Access Compliance Report

(Curb Ramps)

Intersection ID: 30033	Main Street: DILLARD RIDGE DR	Cross Street: SOUTHWIND DR	Location: SE
ADA ID: 7D59F73C4DBB	Ramp Type: PerpDiag	Initial Pass/Fail: Fail	Overall Compliance: No
Codes/Mitigation Info/Possible Solution		Field Measurements/Component Compliance	
Severity Score: 12.5

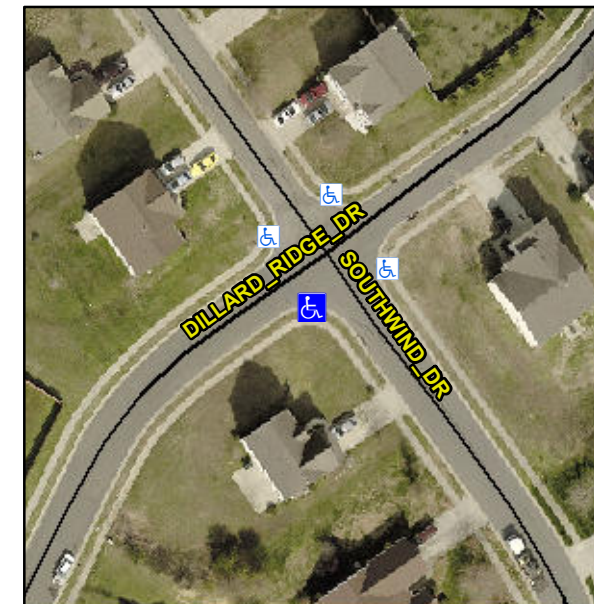
Remove & Replace Curb Ramp With Two New Directional Ramps or Equivalent.

Not Found, R304.2.2

Compliance	Description	Data	Compliance	Description	Data
N/A	Ramp Length (in)	56.0	No	Ramp Slope (%)	10.1
Yes	Ramp Width (in)	48.0	Yes	Ramp XSlope (%)	1.0
N/A	Flare Type LT	N/A	N/A	Flare Type RT	N/A
N/A	Flare Slope LT (%)	N/A	N/A	Flare Slope RT (%)	N/A
N/A	Flare Traversable LT?	N/A	N/A	Flare Traversable RT?	N/A
N/A	Landing Length (in)	N/A	N/A	DWS Provided?	N/A
N/A	Landing Width (in)	N/A	N/A	DWS Contrast?	N/A
N/A	Landing Slope (%)	N/A	N/A	DWS Length (in)	N/A
N/A	Landing X Slope (%)	N/A	N/A	DWS Full Width?	N/A
N/A	Landing Curb? (Y/N)	N/A	N/A	DWS Offset (in)	N/A
N/A	Shared Landing?	N/A			
N/A	Gutter Ponding?	N/A	N/A	Gutter Slope (%)	N/A
N/A	Gutter Lip Ht (in)	N/A	N/A	Gutter X Slope (%)	N/A
N/A	Painted X Walk1?	No	N/A	Painted X Walk2?	No
	X Walk 1 Direction	To NW		X Walk 2 Direction	To N
N/A	X Walk 1 Width (in)	N/A	N/A	X Walk 2 Width (in)	N/A
	X Walk 1 Slope (%)	1.8		X Walk 2 Slope (%)	1.0
	X Walk 1 X Slope (%)	3.8		X Walk 2 X Slope (%)	1.4
